**DEPARTMENT OF TRANSPORTATION
STATE OF GEORGIA**

FILE: CSSFT-0008-00(375) Douglas **OFFICE:** Engineering Services
P.I. No.: 0008375
US 78/SR 8 @ Mason Creek and Post Rd. **DATE:** May 3, 2012

SUBJECT: IMPLEMENTATION OF VALUE ENGINEERING STUDY ALTERNATIVES

**Subject: Value Engineering Study-Responses
CSSFT-0008-00(375) Douglas County
P.I. Number: 0008375
SR 8/US78 @ Mason Creek Road and Post Road
GS&P Project No. 26340.11**

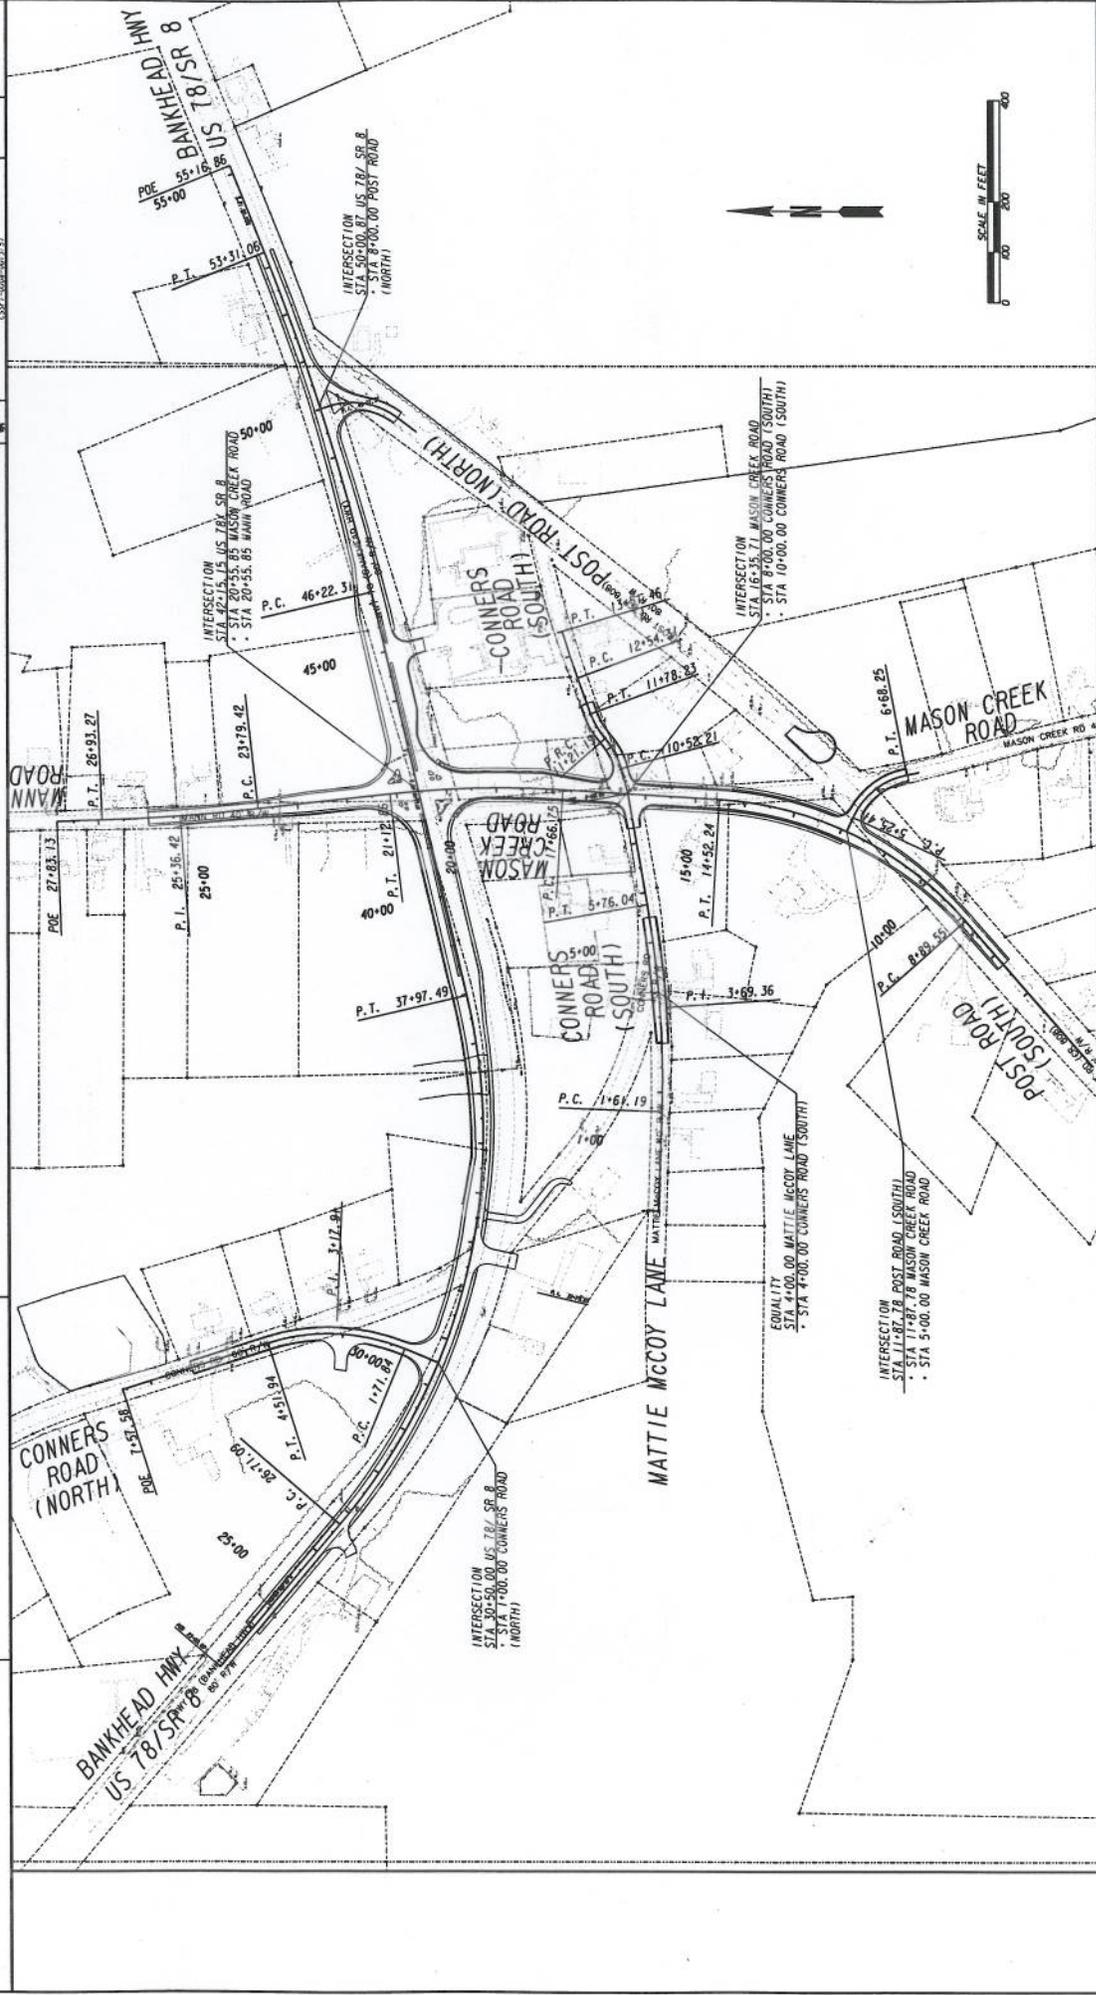
12. Value Engineering Alternative No. S-6 – Change the 4:1 slopes to 2:1 and reduce the amount of right of way required

Approval of the VE Alternative S-6 is not recommended.

- A 2:1 foreslope is non-traversable which would require the use of guardrail with a shoulder that would have an additional 5'-6" width as per GDOT Std. 4052. For the placement of the GDOT Type 12 guardrail approach anchors, a shoulder with an additional 9 ft paved width would be necessary.
- In areas where a standard ditch is utilized, the amount of savings in earthwork or right of way versus the typical section discussed in VE Alternative S-1 would be negligible.
- The placement of guardrail is used to help protect motorists from adjacent potential roadside hazards or non-traversable areas as per the clear zone concept but the guardrail itself can potentially be a hazardous obstacle for a vehicle that leaves the roadway. The 2004 *AASHTO*
